Recall Bulletin

PRODUCT SAFETY RECALL

SUBJECT: Side Impact Sensor (SIS) Wire Chafe at Window Regulator

MODELS: 2010 Chevrolet Cobalt 4-Door Sedan

4141990

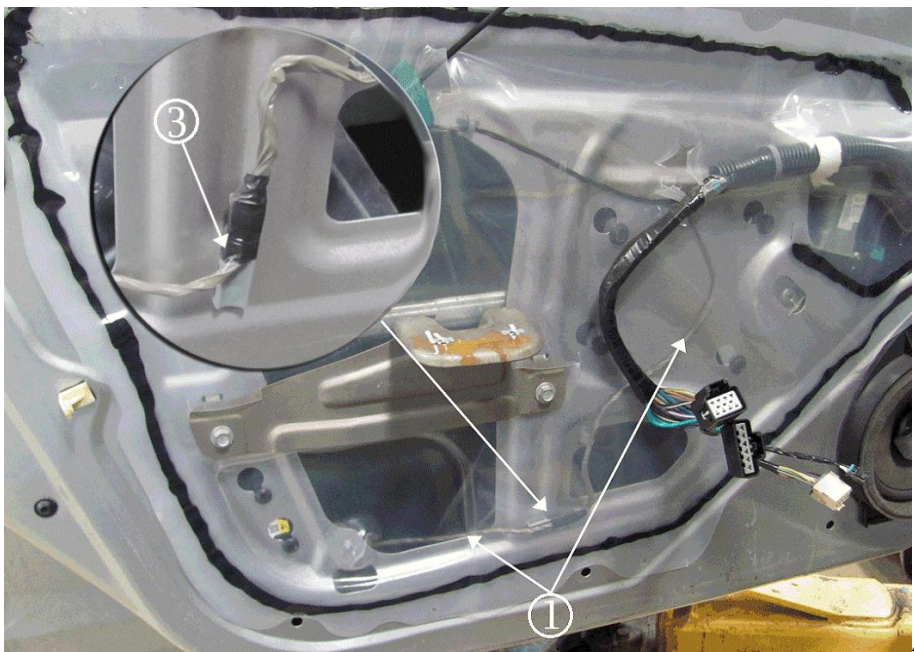
2. Locate the side impact sensor (SIS) wire harness (1).
3. Determine if the SIS wire harness clip is in the horizontal or vertical position.
 - If the SIS wire harness clip is positioned in the horizontal position (2), cycle the window to ensure that the SIS wire does NOT contact the window regulator.
 - If the SIS wire harness does NOT contact the window regulator, no further action is required. Re-install the front driver side door trim panel. Refer to *Front Side Door Trim Panel Replacement* in SI.
 - If the SIS wire harness does contact the window regulator, proceed to step 4.

4141996

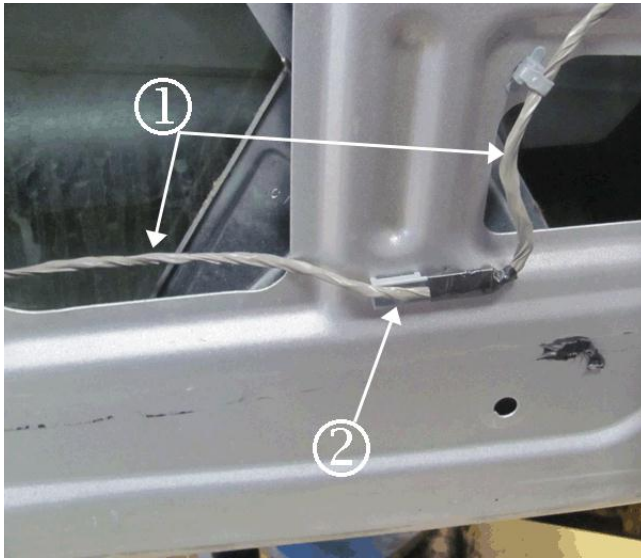
- If the SIS wire harness clip is positioned in the vertical position (3), partially remove the vapor barrier to gain access to the SIS wiring harness and clip. Remove the pull cup bracket to partially remove the vapor barrier. Proceed to step 4.

4142109

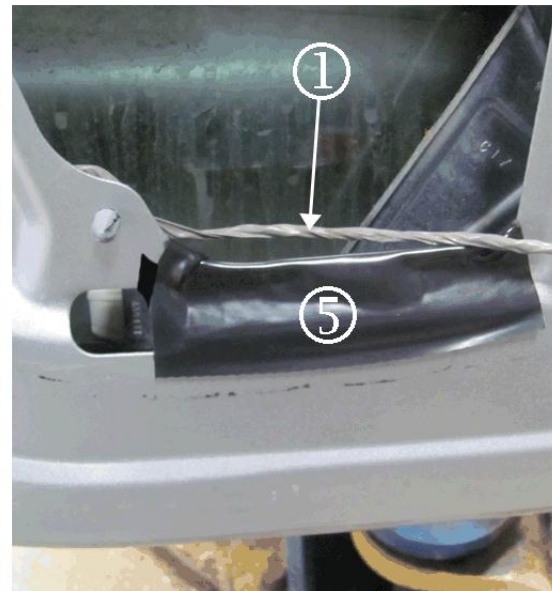
4. Determine if the SIS wire harness (1) is damaged.
 - If the SIS wire harness (1) is NOT damaged, proceed to step 5.
 - If the SIS wire harness (1) is damaged, repair the wire harness. Refer to *Repairing Damaged Wire Insulation* and/or *Wiring Repairs* in SI. Proceed to step 5 after completing the wire repair.
5. Install the SIS wiring harness clip in the horizontal position (2).

4142091

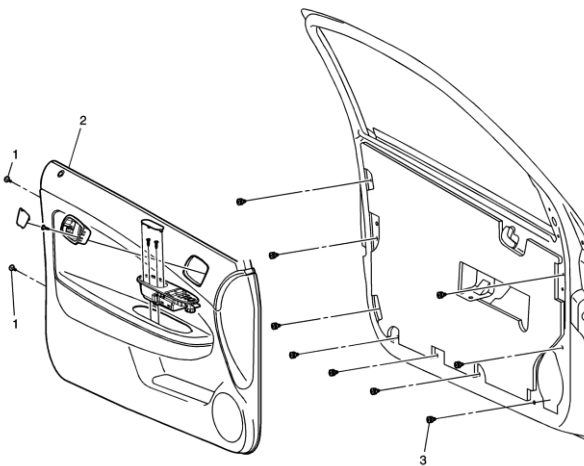
6. Apply a 114 mm (4.5 in) piece of Scotch Electrical Moisture Sealant Tape, P/N 06147 or equivalent (5) to metal edge of the door (4) as shown in the photograph.
